ECONOMISER ASSEMBLY

DRG NO : EC-01-GA-001

BOM CHECK SUMMARY

Drawing : sample_01_drawing.pdf (Rev B)
BOM : sample_01_bom.xlsx (Rev B)
Input : vector PDF
RUN RELIABILITY : HIGH

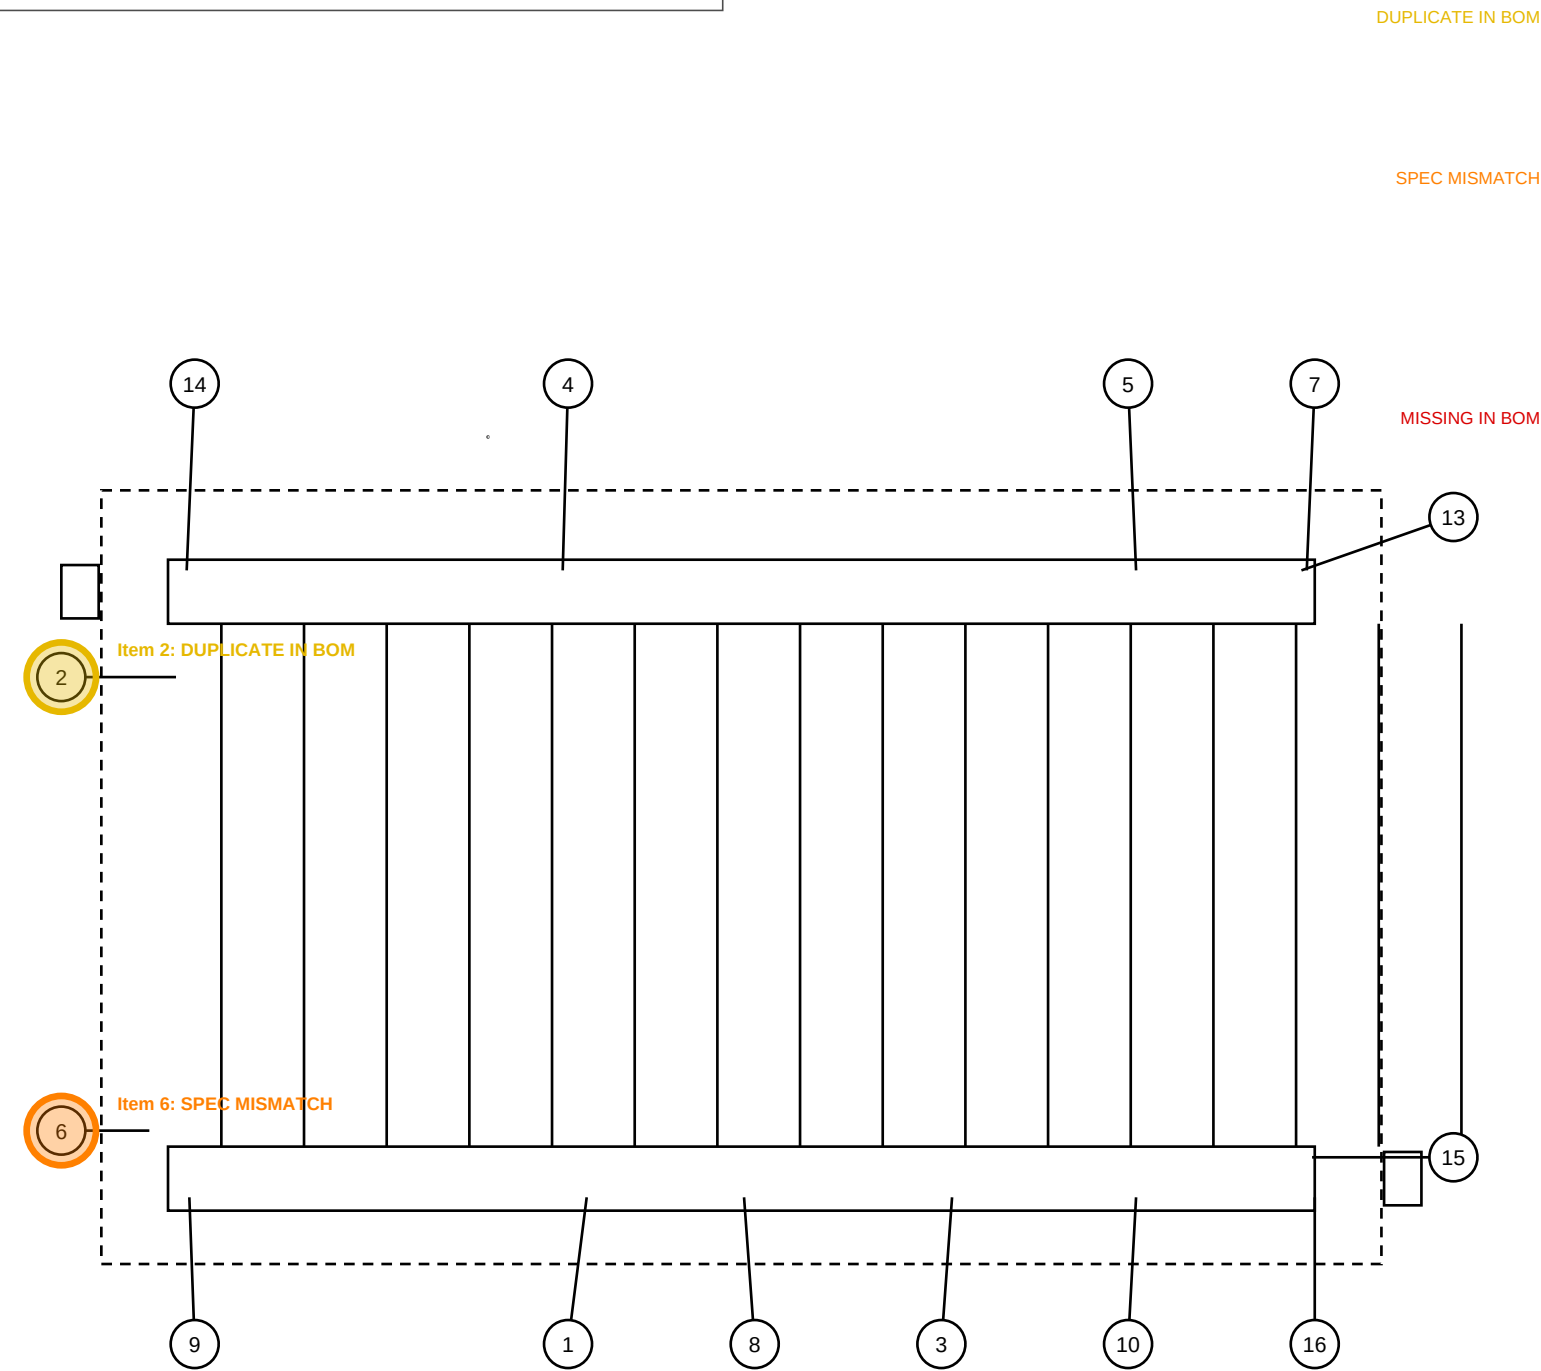
[RED] Item 12 'STUD BOLT M20 X 90 WITH 2 NUTS' (qty 16) is on the drawing but has no BOM line
[ORANGE] Item 6: specification mismatch - dimension: drawing ['200'] vs BOM ['250']
[YELLOW] BOM row 23 'Outlet header 219.1 OD x 8 thk' repeats item 2 (already covered by BOM row 7)
[BLUE] Suggestion (Cladding): the drawing notes imply it, but no matching line was found in the BOM
